**COUNTY OF SAN MATEO
PLANNING AND BUILDING DEPARTMENT**

SUBJECT: EXECUTIVE SUMMARY: Consideration of a Non-Conforming Use Permit, Coastal Development Permit, and Design Review Permit, pursuant to Sections 6133.3b, 6328.4 and 6565.3 of the San Mateo County Zoning Regulations, respectively, to allow construction of a new 1,732 sq. ft., two-story single-family residence, plus a 380 sq. ft. two-car attached garage, located on an existing 4,400 sq. ft. legal non-conforming parcel where the S-94 Combining District requires a minimum parcel size of 10,000 square feet. The project includes extension of Cortez Avenue by approximately 60 feet for project access and a new firetruck turnaround. The Non-Conforming Use Permit is required to allow development on a non-conforming parcel that proposes right and left side setbacks of 7 feet each, where 10 feet is the minimum allowed for each side. No trees are proposed for removal. The project is not appealable to the California Coastal Commission.

County File Number: PLN 2018-00397 (Irfan)

Exterior LIGHTENING Plan

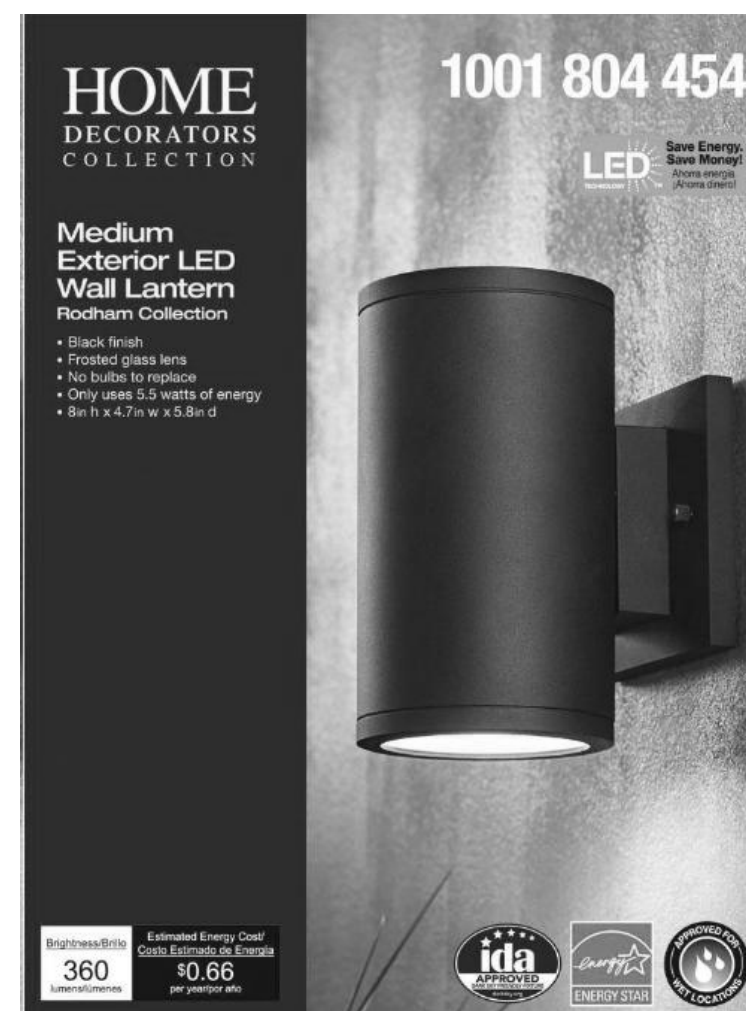
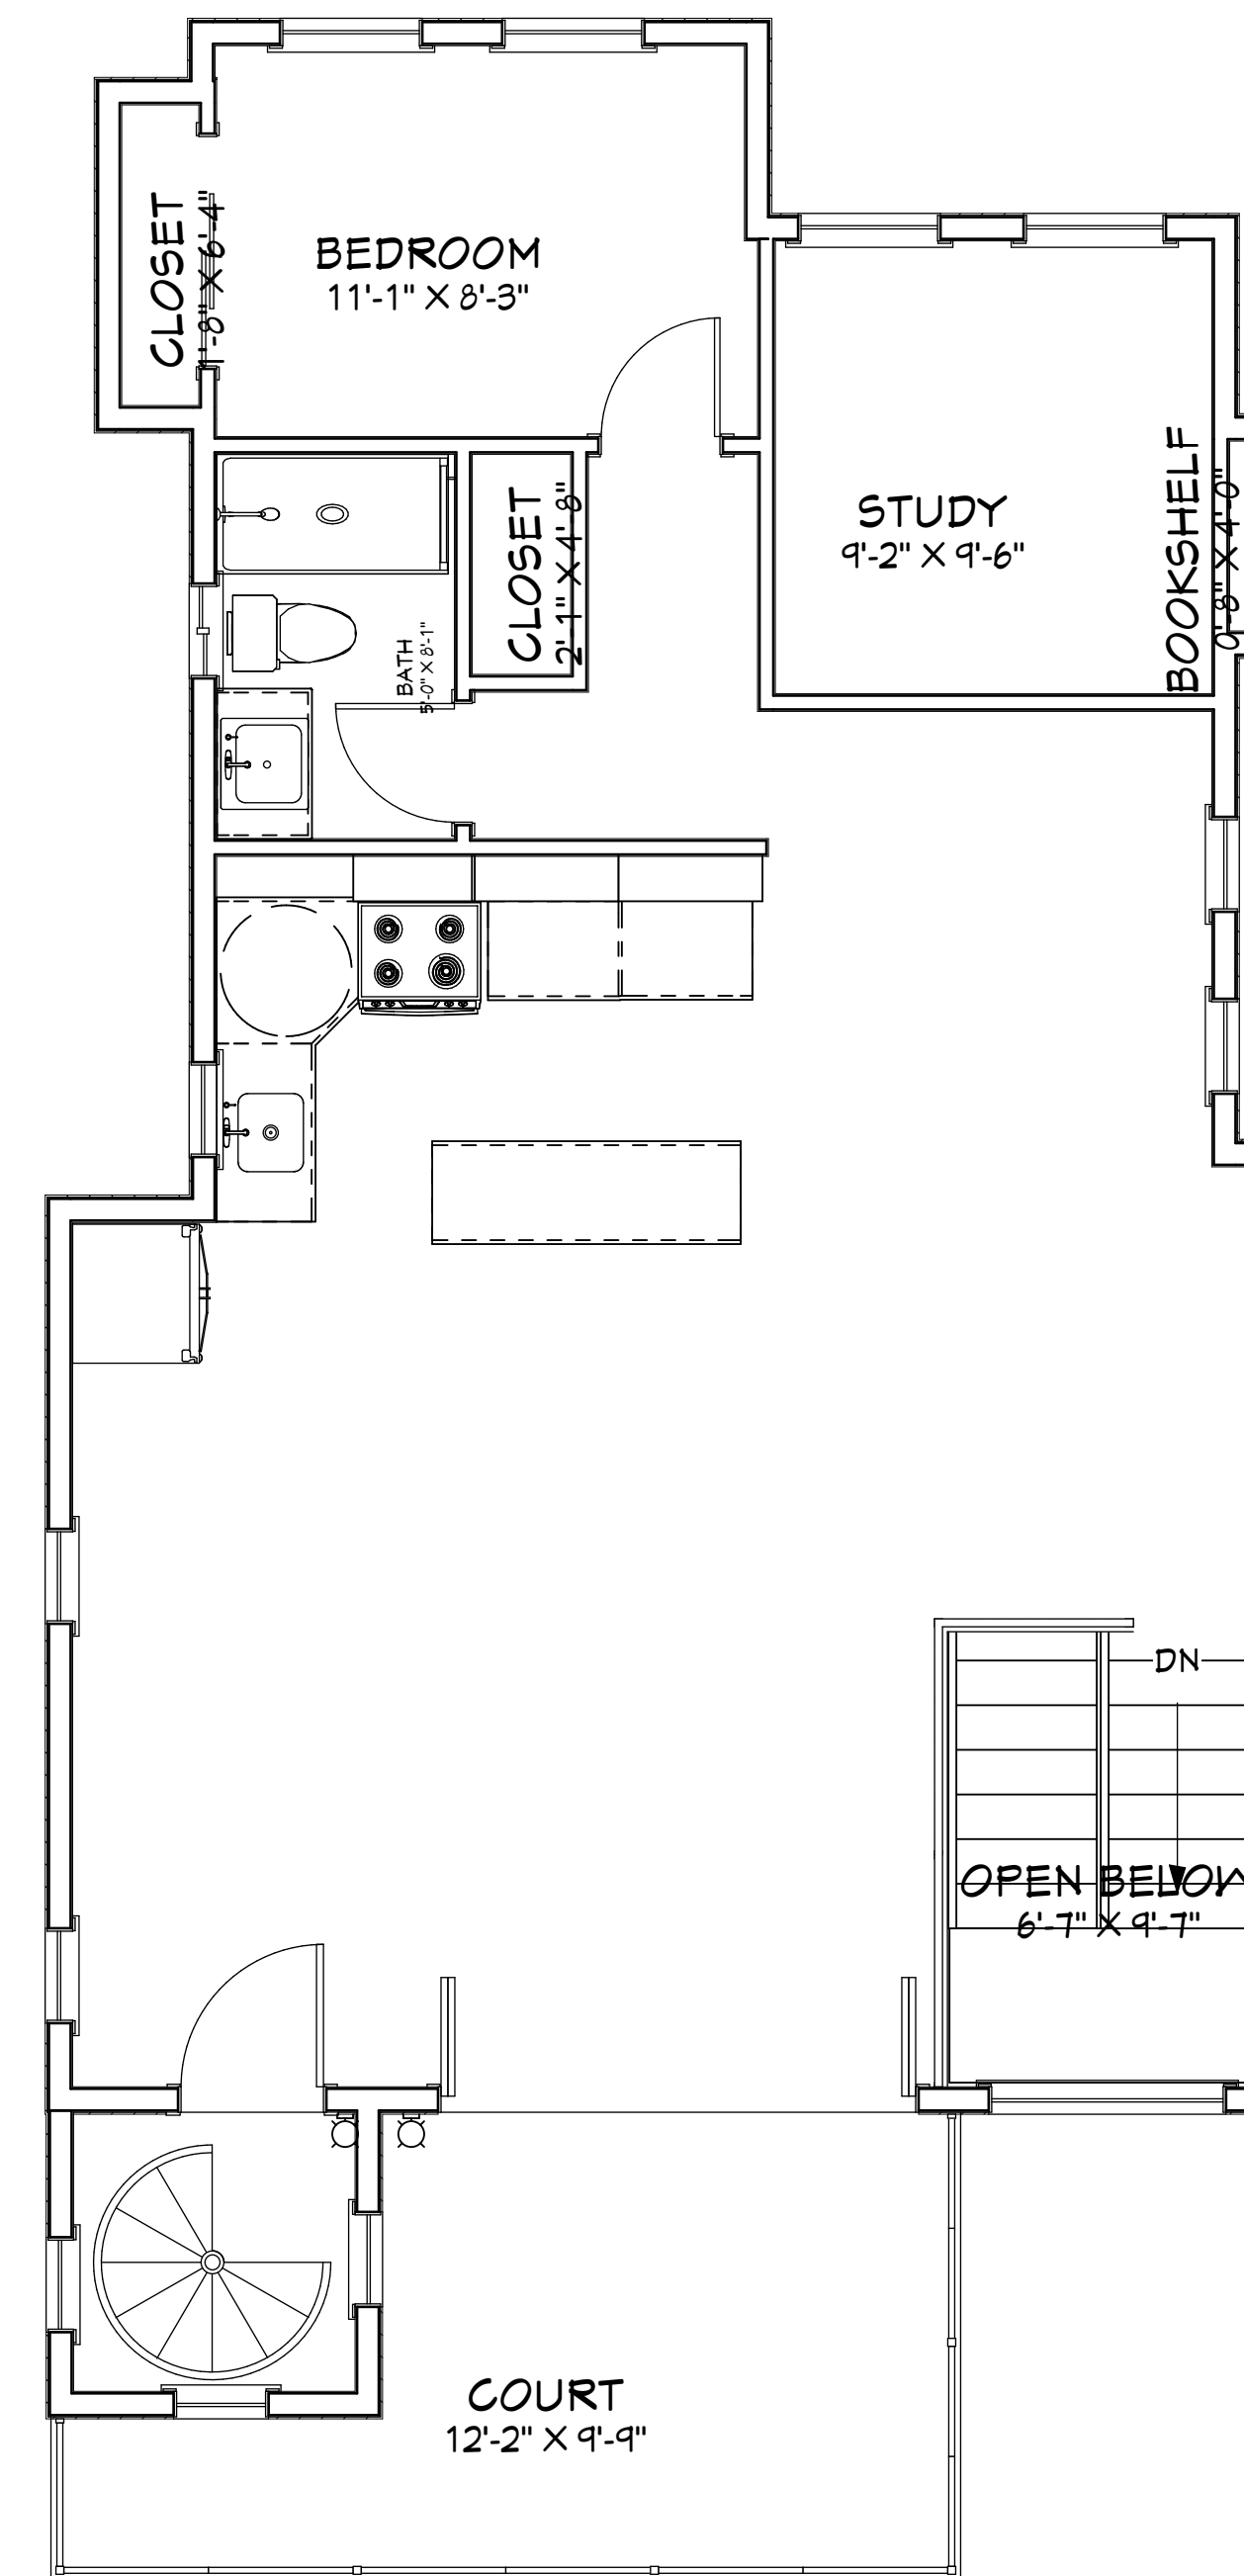
1. Outdoor lighting reduced to one light fixture near doors only
Redesign: Remove all lighting. Total exterior light now reduced to 5. 2 for front patio and then 1 each exterior door.
